Re: Dairy Farmers of America, Cabool, MO

**UNSATISFACTORY FINDINGS
RESPONSE REQUIRED**

**Missouri Department of Natural Resources
Southeast Regional Office/Water Protection Program
Report of Inspection
Dairy Farmers of America, Cabool, MO
950 Metrecal Trace Street/Cabool/Texas County
MO-0002828
July 31, 2019**

Photo #: 010
By: John Chronister
Facility: Dairy Farmers of America, Inc.

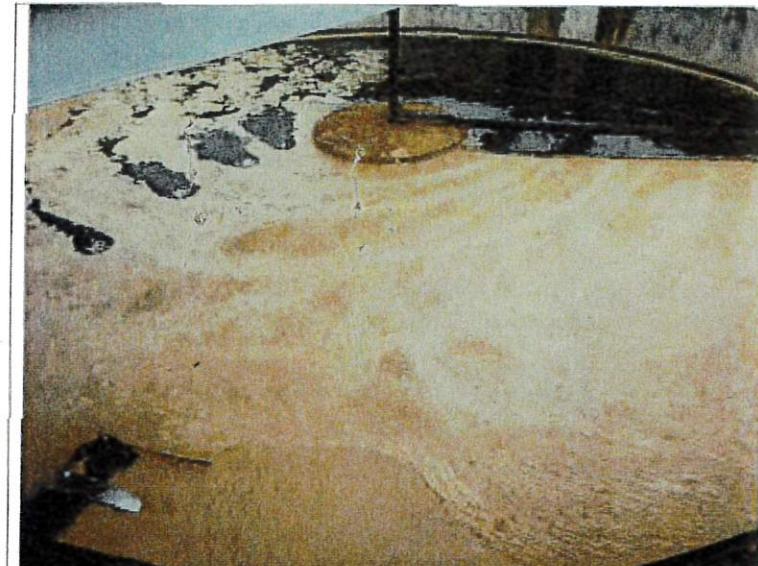
1. The material observed on the final clarifiers and in the "mixing basin" is similar in appearance to the material accumulating in and causing operational issues with the Cabool Wastewater Treatment Facility (WWTF).

Required Action: Every effort must be made to prevent the material observed on the final clarifiers and in the "mixing basin" from being discharged to the City of Cabool's collection system. It is possible this material is causing or contributing to interference and/or pass through at the Cabool WWTF, which is a violation of General Pretreatment Regulations, 40 CFR Part 403. Please keep the Department informed regarding efforts or planned upgrades to minimize these potential occurrences.

Photo #: 015
By: John Chronister
Facility: Dairy Farmers of America, Inc.

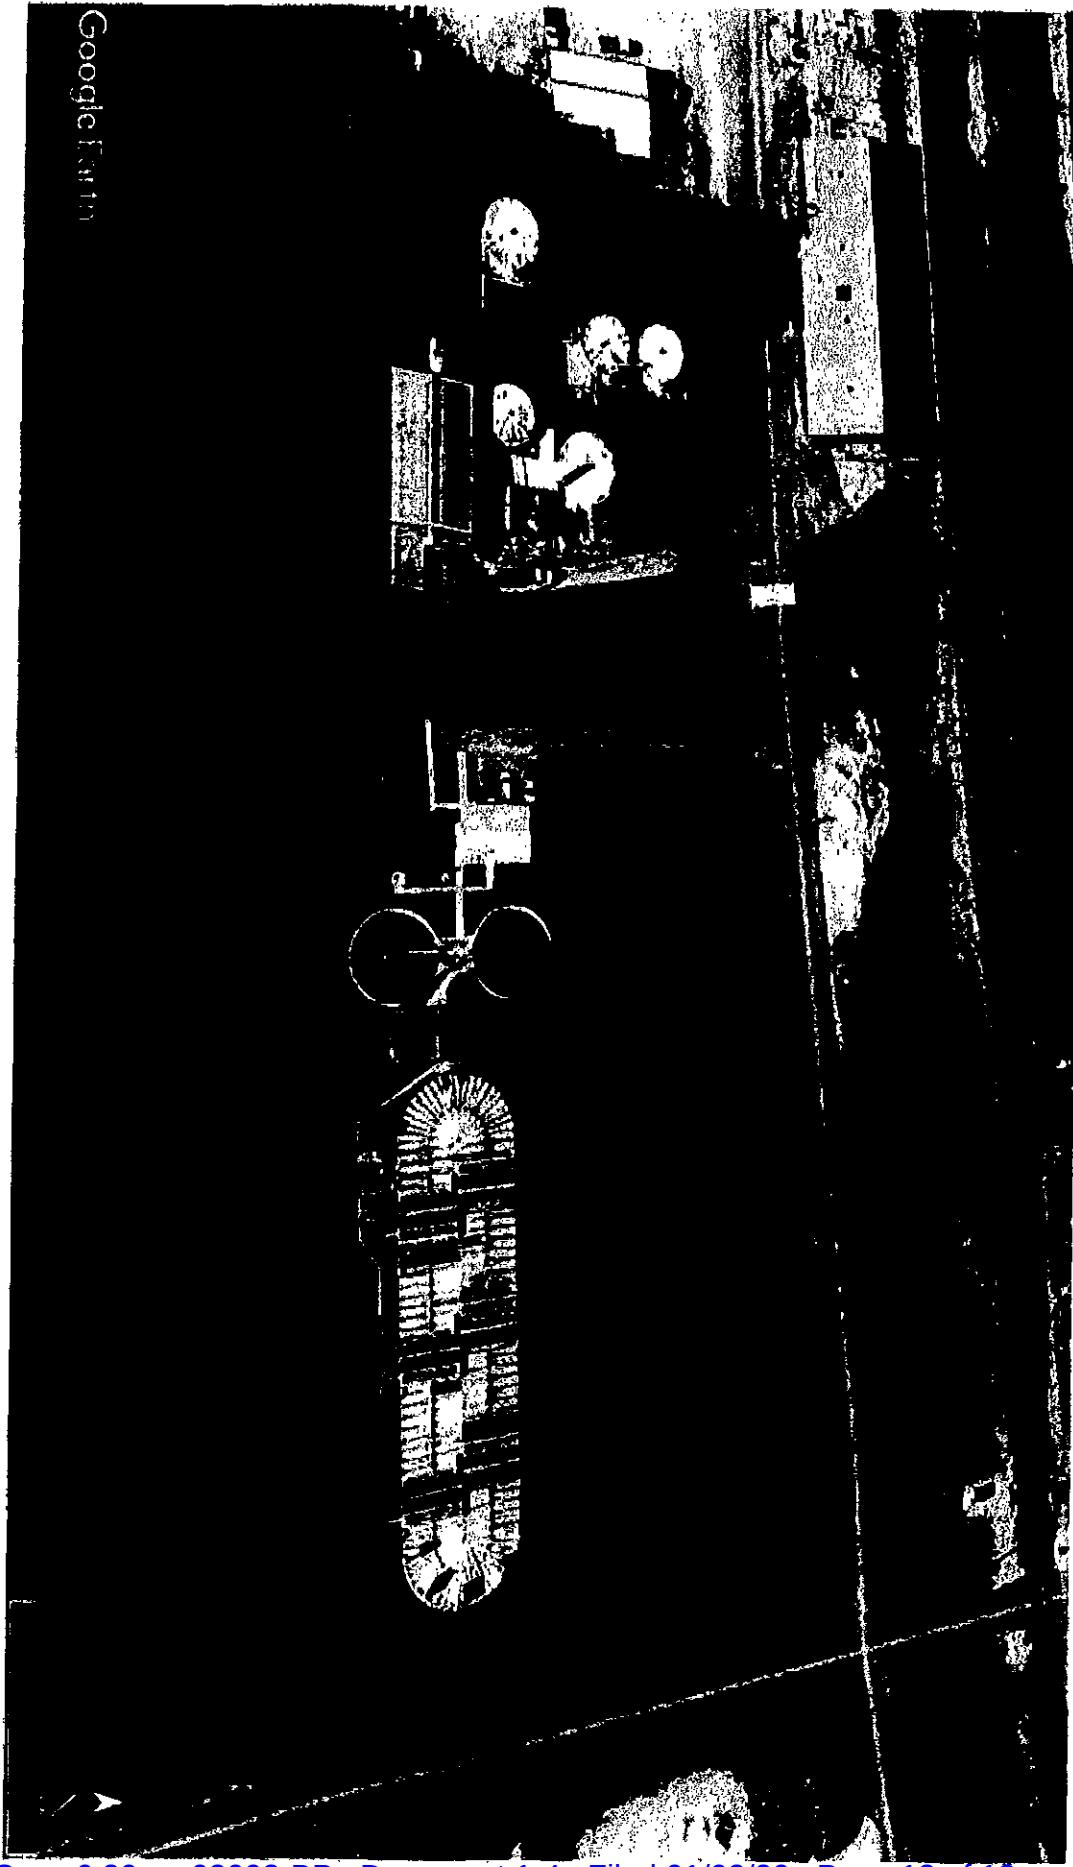
3. The permitted features were not marked as required by MSOP MO-0002828.

Required action: By September 2, 2019, post signs at permitted features with their respective numbers (Permitted Feature 005, Permitted Feature 006, etc).
